Technical Service Information

THM 4L60 (700-R4)

CLICKING/WHINE NOISE IN 3RD & 4TH GEARS

Figure 1

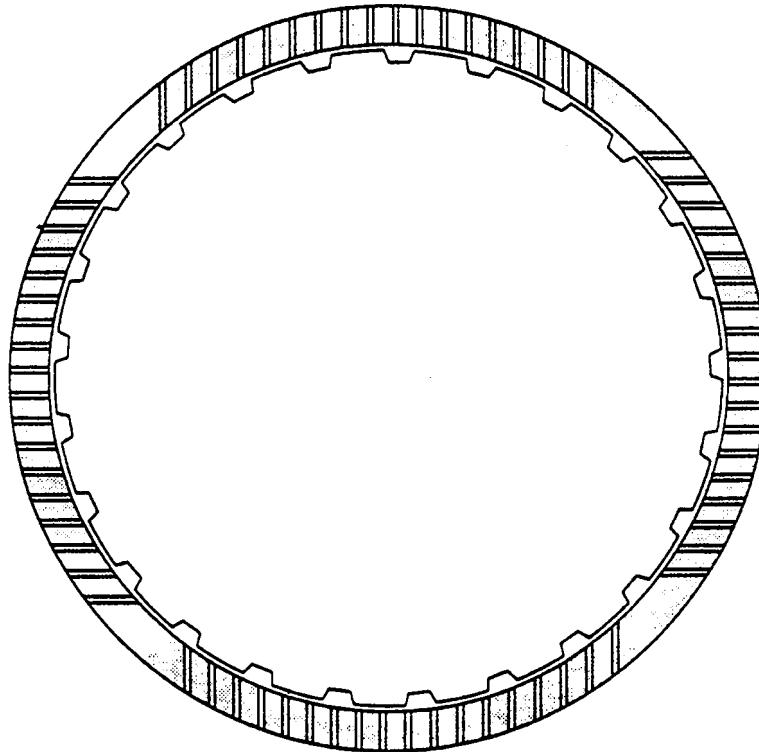
COMPLAINT: Some 1988-1992 vehicles equipped with the THM 4L60 (700-R4) transmission may exhibit a "Clicking", "Whining", "Ticking", or "Rattle" noise when operating in 3rd and/or 4th gear.

CAUSE: The cause may be transmission fluid passing over the friction plates of the Low/Reverse clutch pack. The fluid causes them to vibrate because of the groove pattern.

CORRECTION: Install five new friction plates, OEM part number 8681813, in the Low/Reverse clutch pack. The new plates have a different groove pattern so they do not vibrate in 3rd and 4th gear.

Low/Reverse Clutch Plate (Friction) 8681813
